1988/1989 GL1500 SADDLEBAG WATER LEAKAGE

Some 1988/1989 GL1500 owners may complain about water leakage into the saddlebags while riding in the rain or washing the motorcycle.

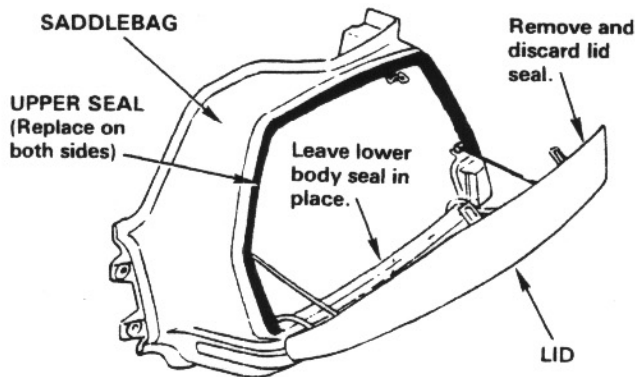
An improved saddlebag body seal is now available. The new seal is preformed and thicker, eliminating the need for the lid seal.

1. Remove and discard the left and right upper saddlebag body seals. Leave the lower body seals in place (both sides).

2. Remove and discard both lid seals.
NOTE: The lid seal is not required with the new, thicker body seal.
3. Remove any glue residue on the saddlebags or lids.

4. Attach the new seals using Hondaline Weatherstrip Cement (H/C: 1724426), 3M Fast-Tack #08031, or equivalent. Follow the manufacturers directions to assure complete drying.
